**UNIFORM STANDARD DRAWINGS
CLARK COUNTY AREA**

VOLUME I - YEAR 2008 REVISIONS

| | | DATE 6-12-08 | DWG. NO. 500 AT |

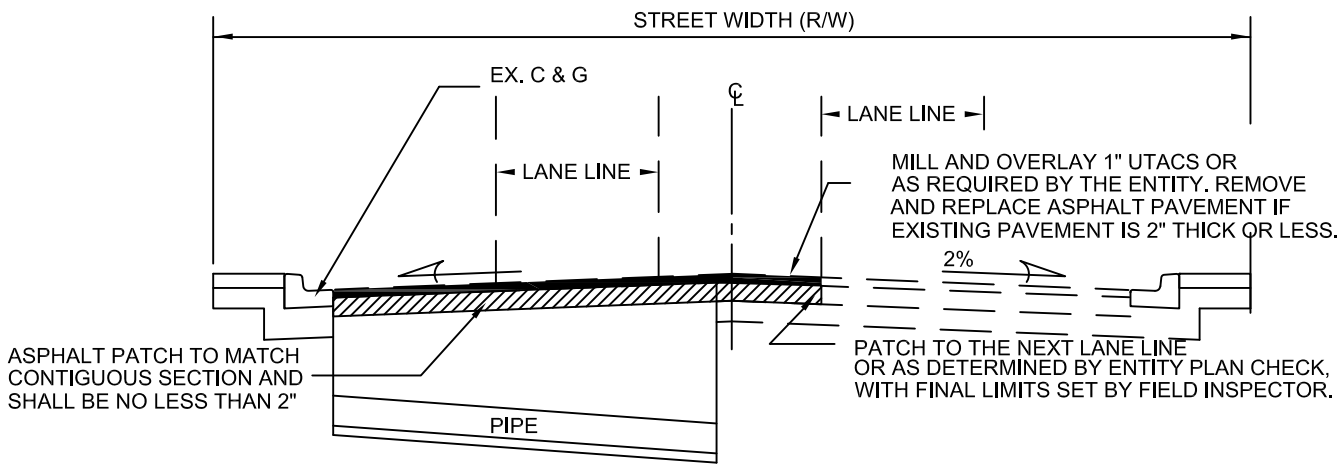
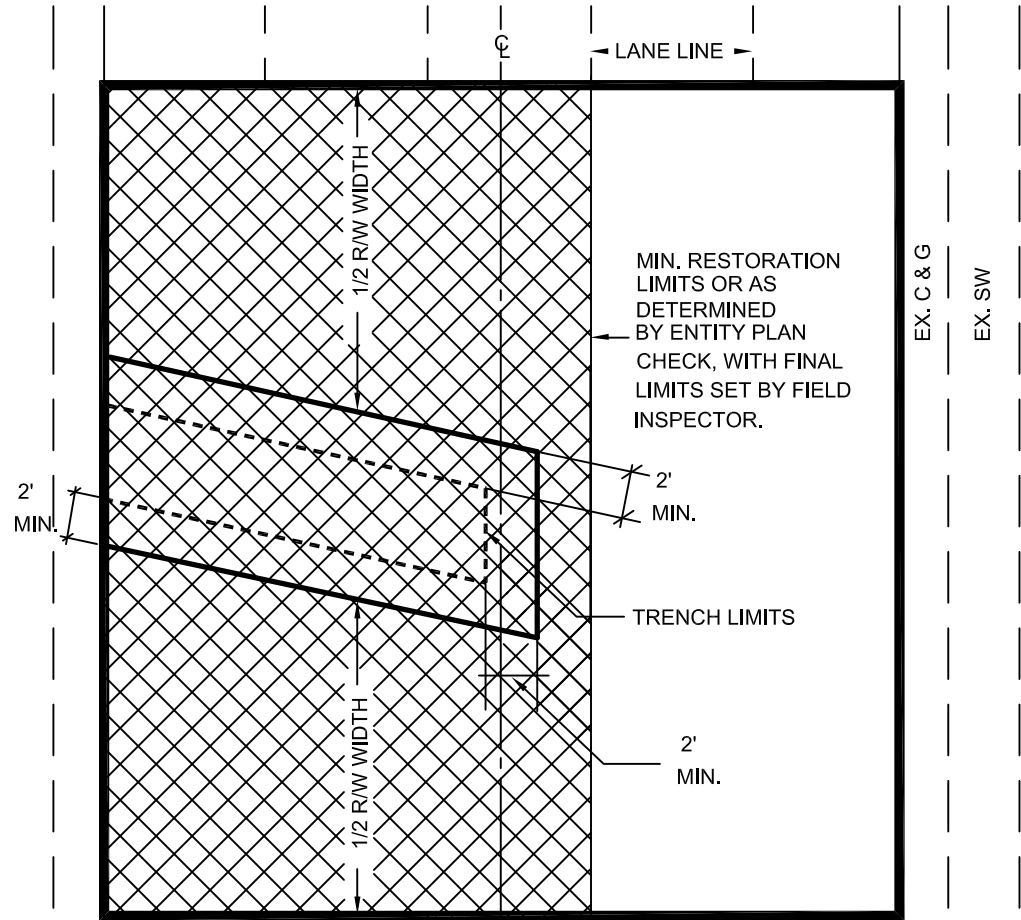
| Drawing Number | Title | Nature of Change | Effective Date |
|-----------------------|--|--|-----------------------|
| 500AT | "0 To 5 Years Pavement Restoration Transverse Cut" | Addition to incorporate new Standards from the Recommendations of the recent pavements cut study and trench working group. | 07/01/08 |

| | | DATE 6-12-08 | DWG. NO. 500BL1 |

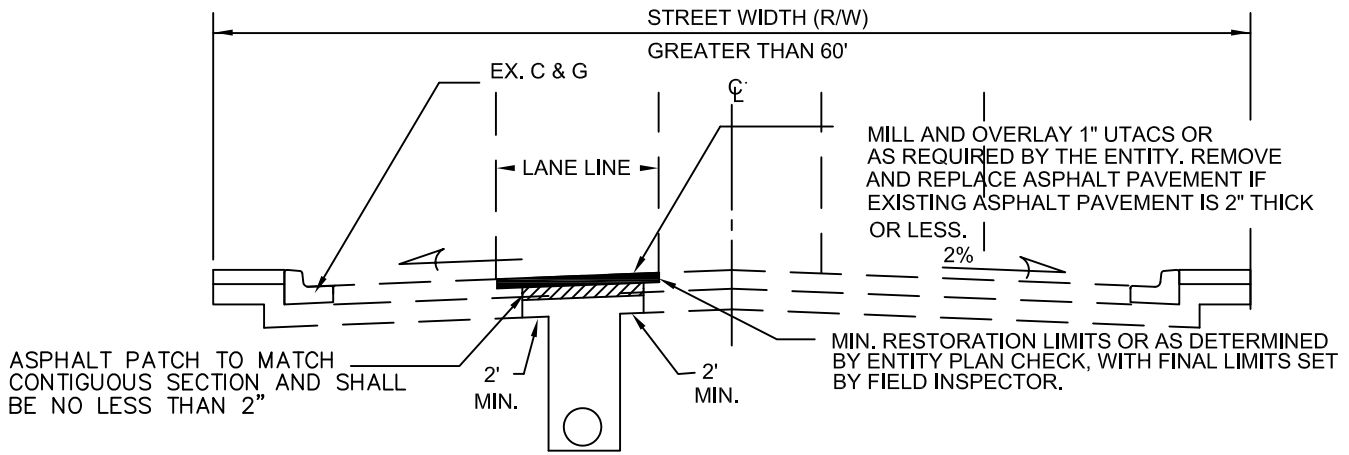
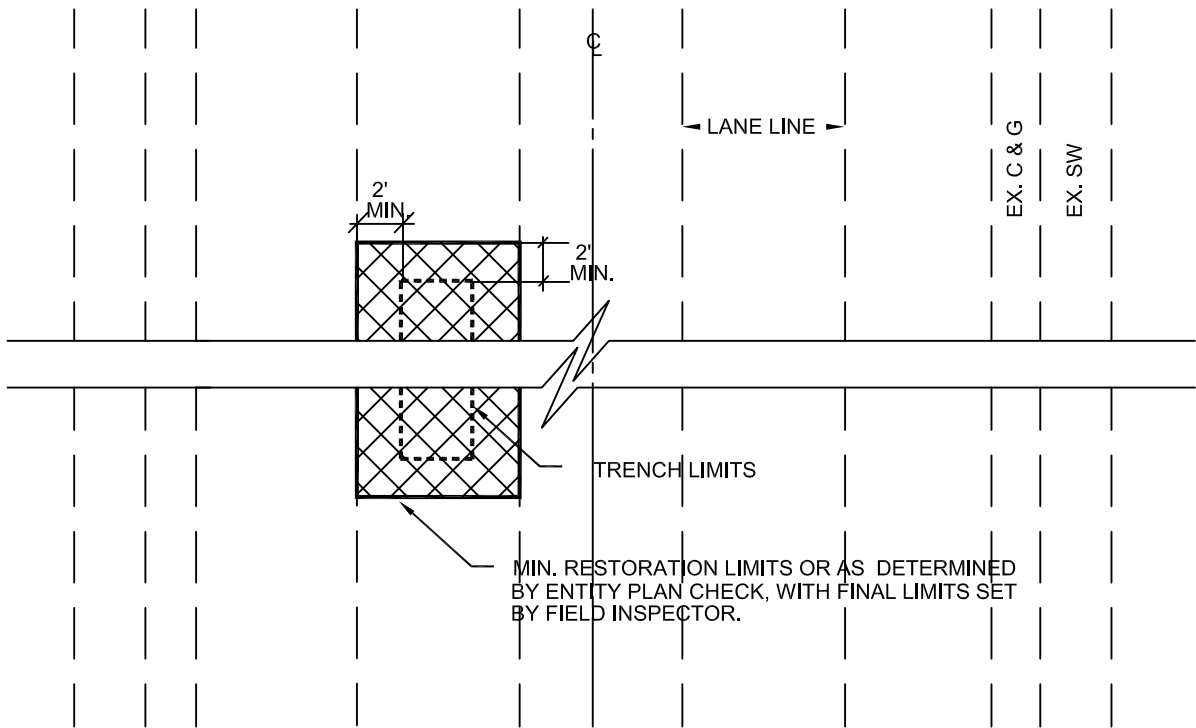
| Drawing Number | Title | Nature of Change | Effective Date |
|-----------------------|--|--|-----------------------|
| 500BL1 | "Over 5 Years Pavement Restoration Longitudinal Cut – Greater Than 60'R/W" | Addition to incorporate new Standards from the Recommendations of the recent pavements cut study and trench working group. | 07/01/08 |

| SPECIFICATION REFERENCE | | UNIFORM STANDARD DRAWINGS CLARK COUNTY AREA | |
|-------------------------|---------------------|---|-----------------|
| | | DATE 6-12-08 | DWG. NO. 500BL2 |

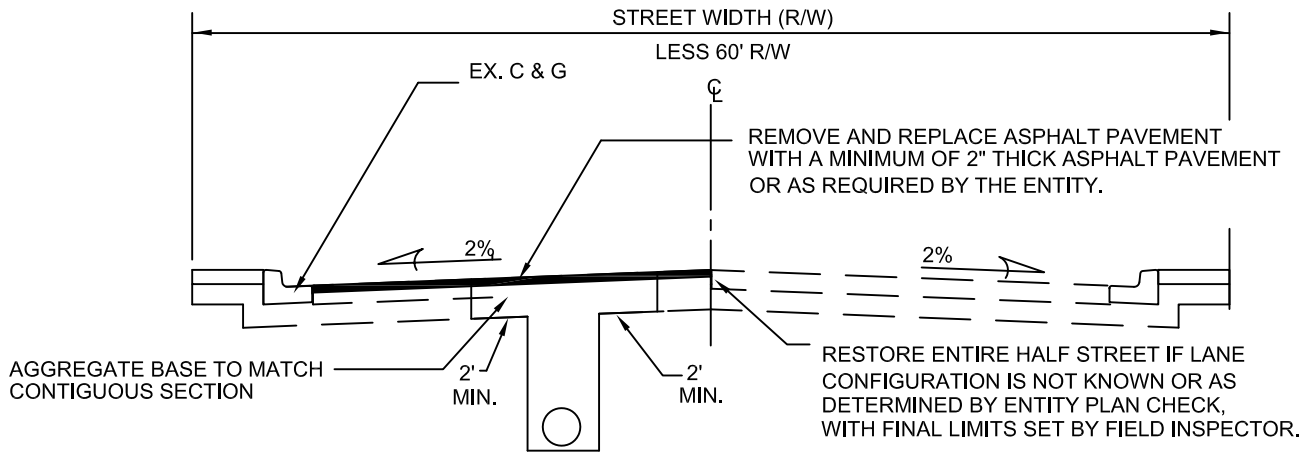
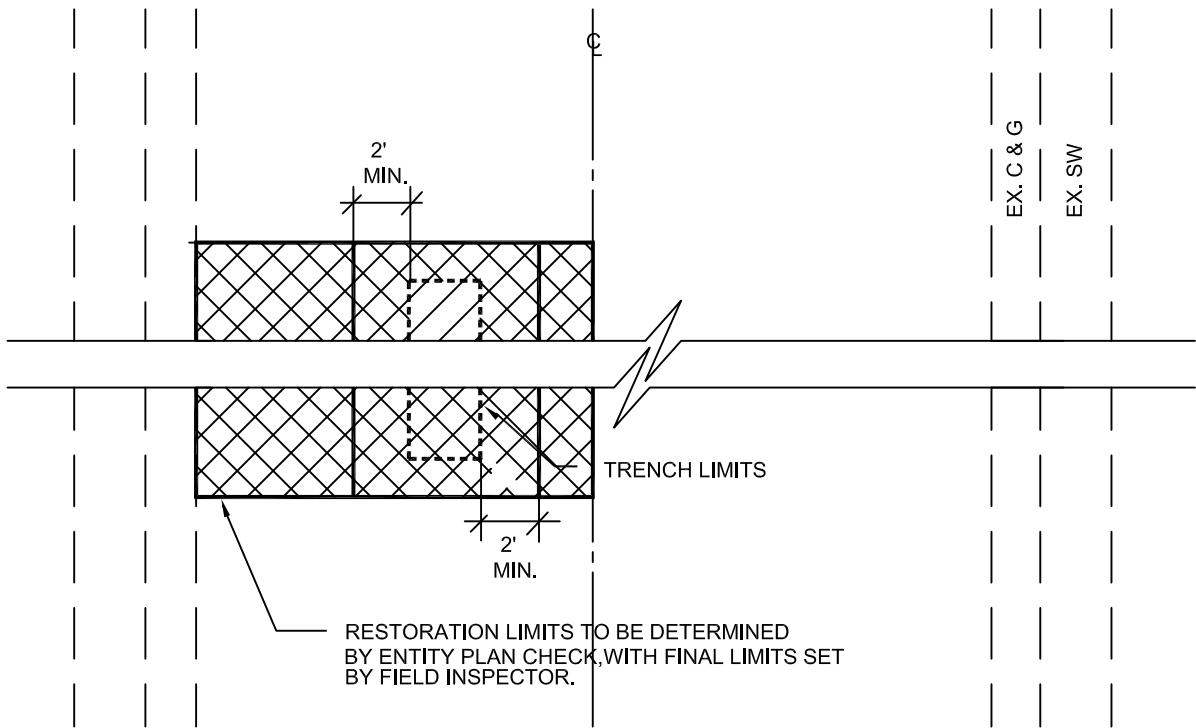
| Drawing Number | Title | Nature of Change | Effective Date |
|-----------------------|--|--|-----------------------|
| 500BL2 | "Over 5 Years Pavement Restoration Longitudinal Cut – Greater Than 60'R/W or Less" | Addition to incorporate new Standards from the Recommendations of the recent pavements cut study and trench working group. | 07/01/08 |

| | | DATE 6-12-08 | DWG. NO. 500BT |

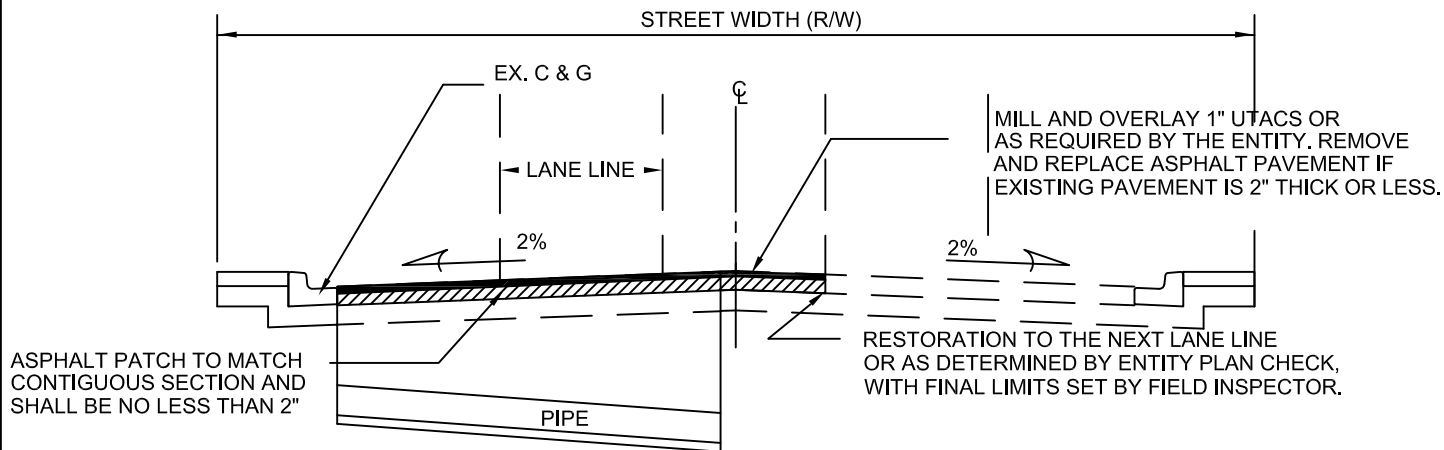
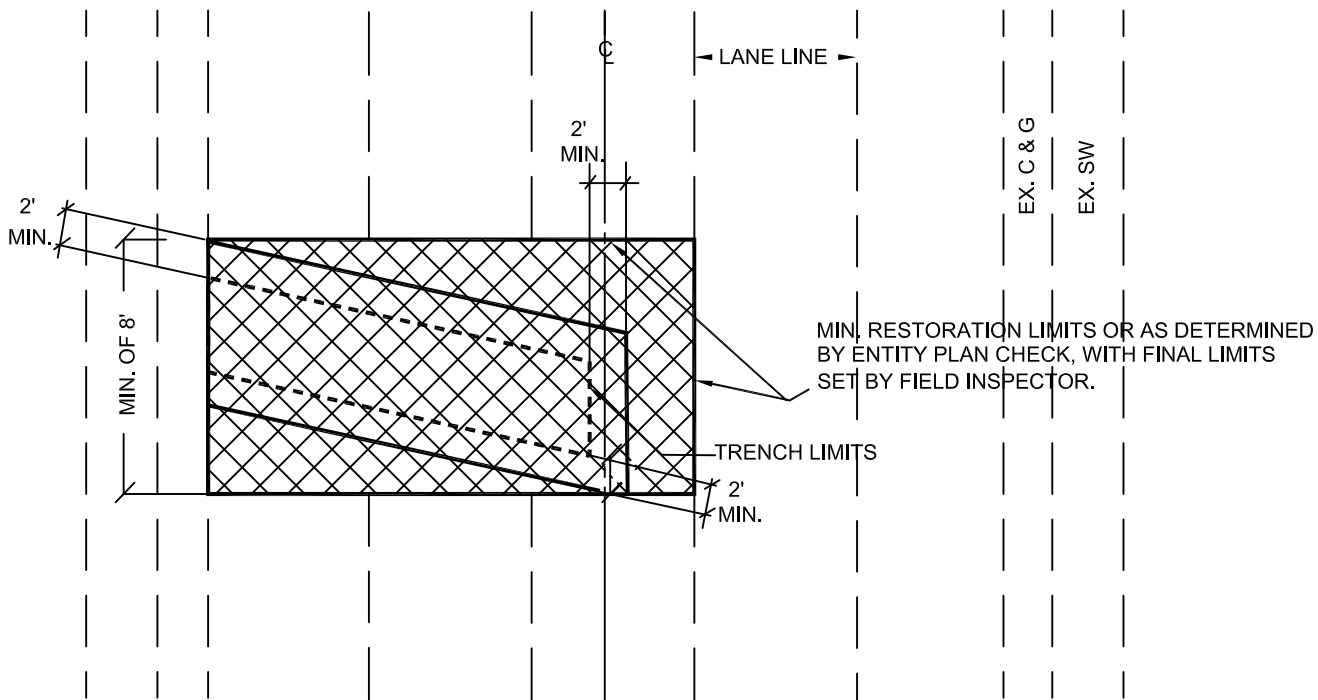
| Drawing Number | Title | Nature of Change | Effective Date |
|-----------------------|--|--|-----------------------|
| 500BT | "Over 5 Years Pavement Restoration Transverse All R/W Widths" | Addition to incorporate new Standards from the Recommendations of the recent pavements cut study and trench working group. | 07/01/08 |

| | | DATE 6-12-08 | DWG. NO. 503A |

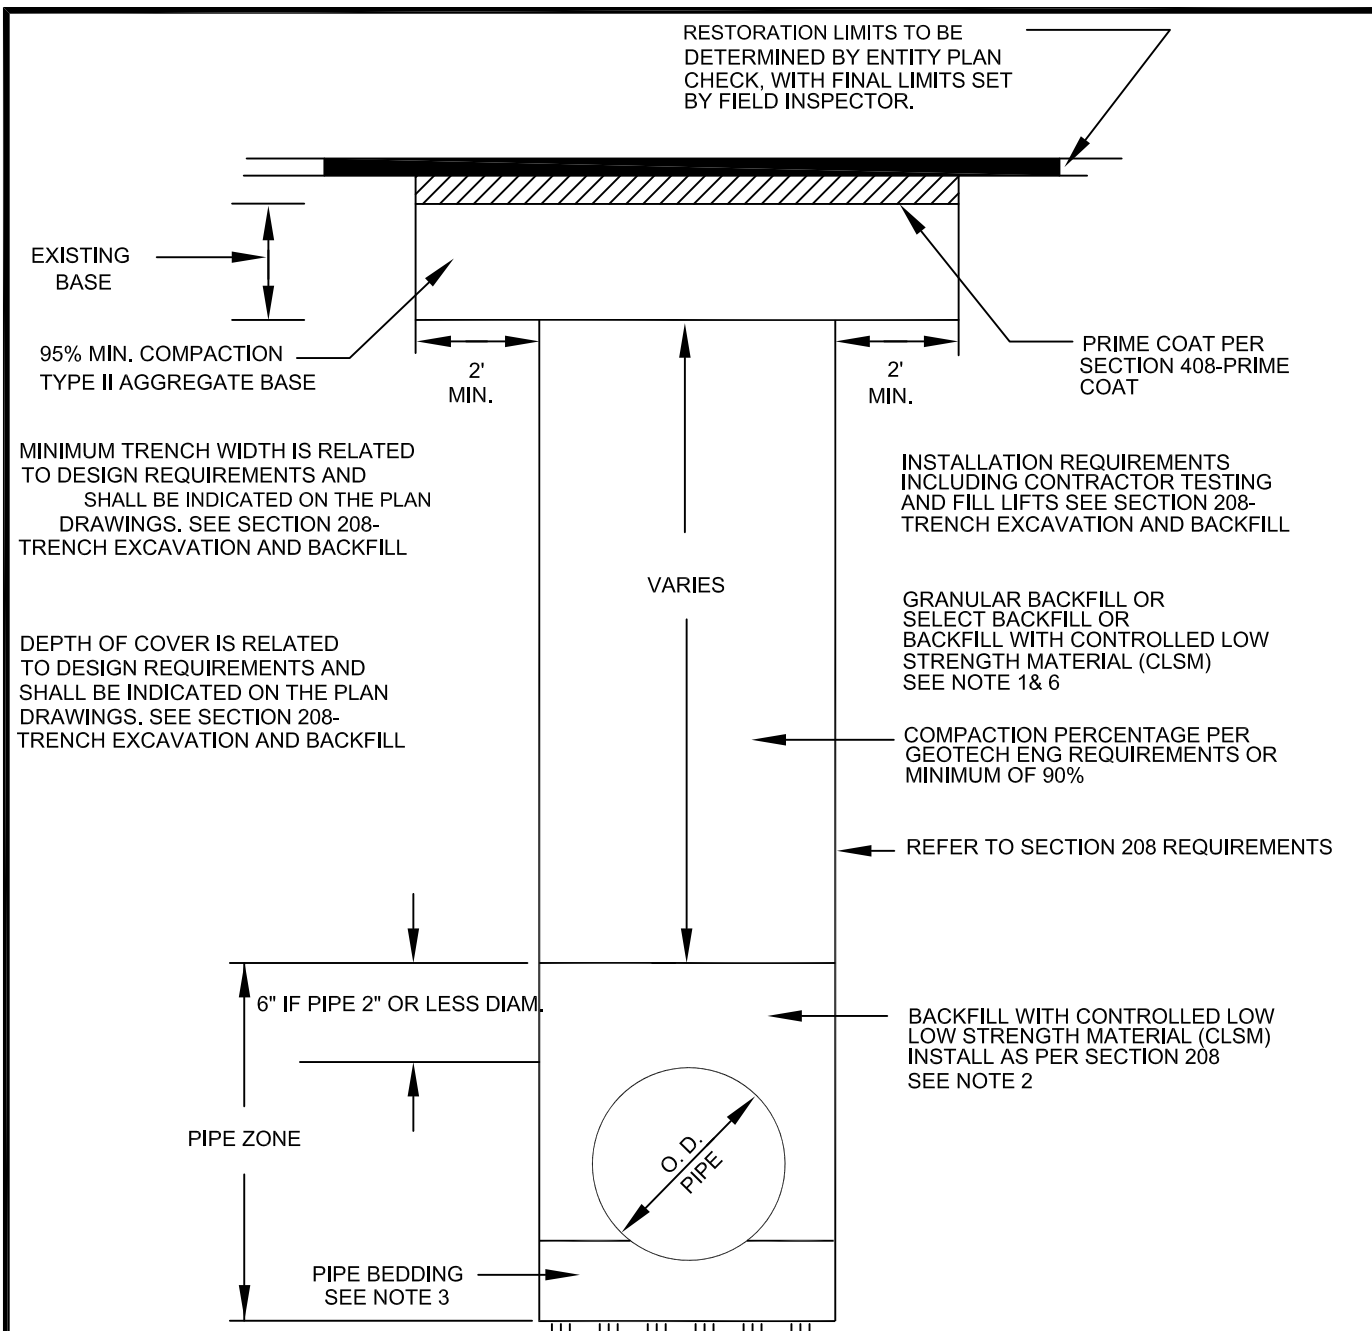
| 503A | "Method For Flexible Pipe Trench Backfill – Paved Areas" | Revision to incorporate new Standards from the Recommendations of the recent pavements cut study and trench working group. | 07/01/08 |

| | | DATE 6-12-08 | DWG. NO. 503B |

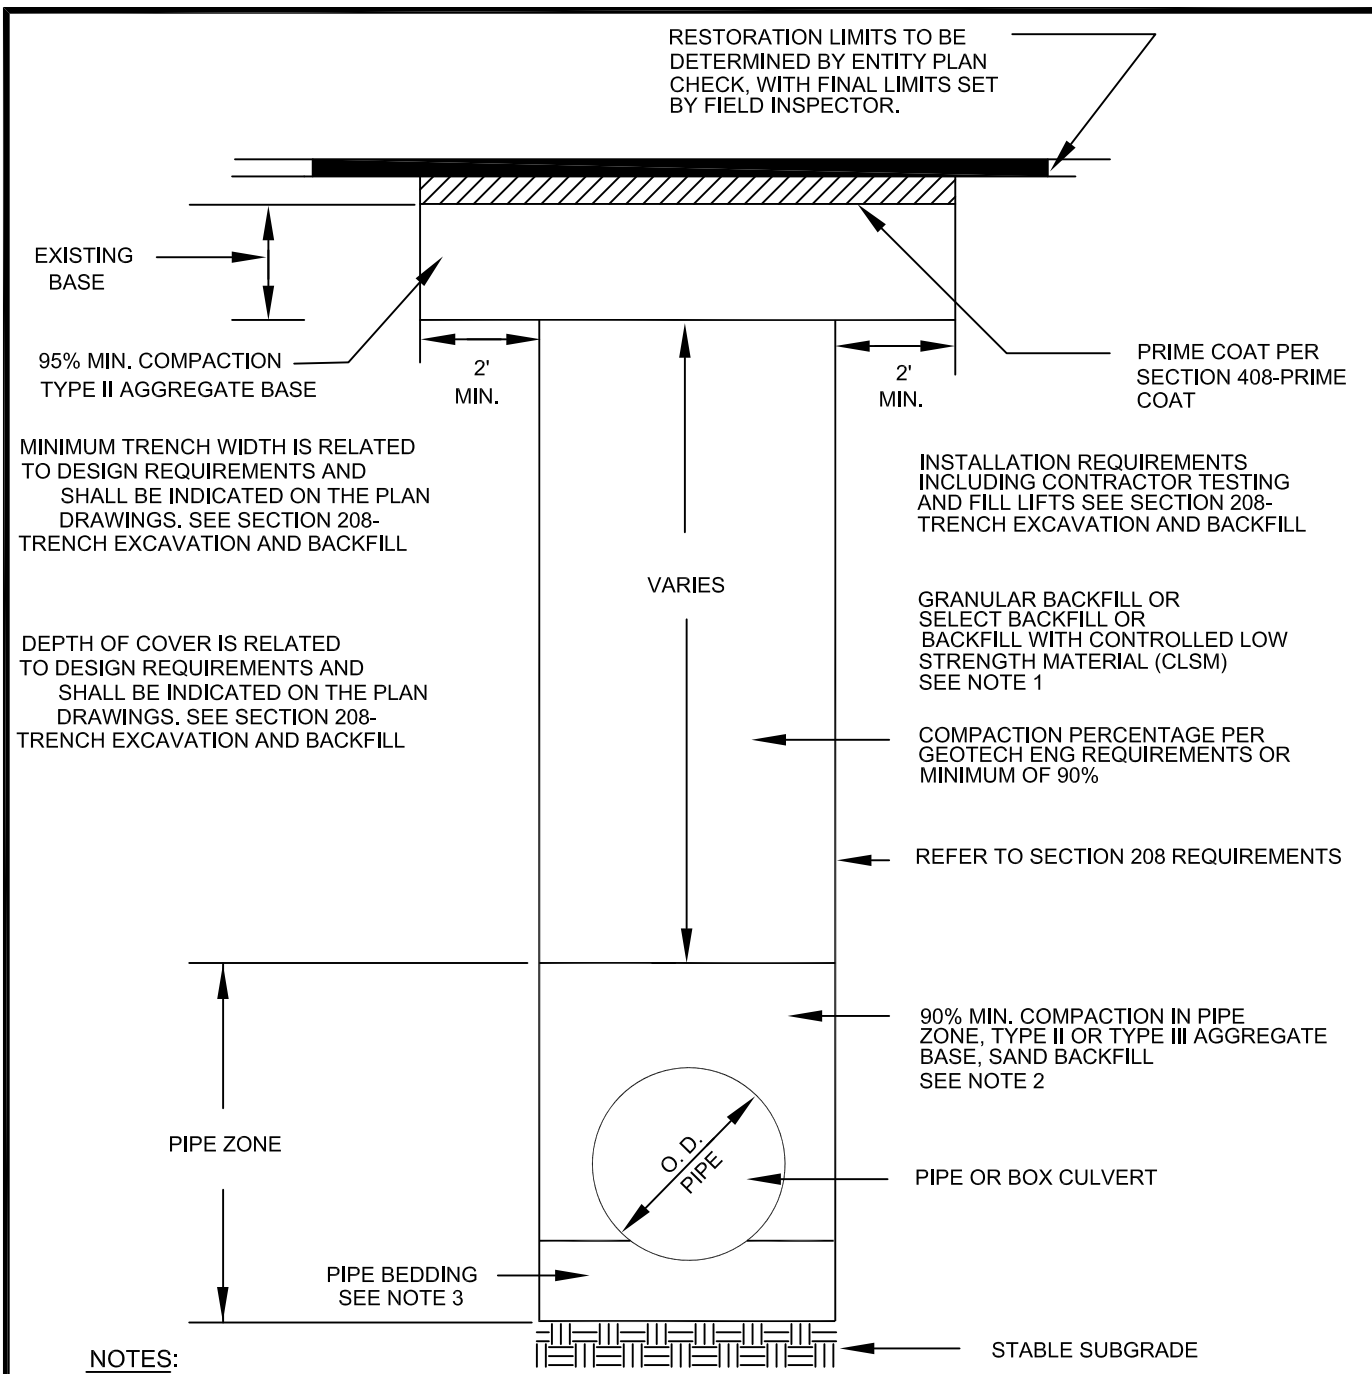
| 503B | "Method For Rigid And Flexible Pipe Trench Backfill – Paved Areas" | Revision to incorporate new Standards from the Recommendations of the recent pavements cut study and trench working group. | 07/01/08 |
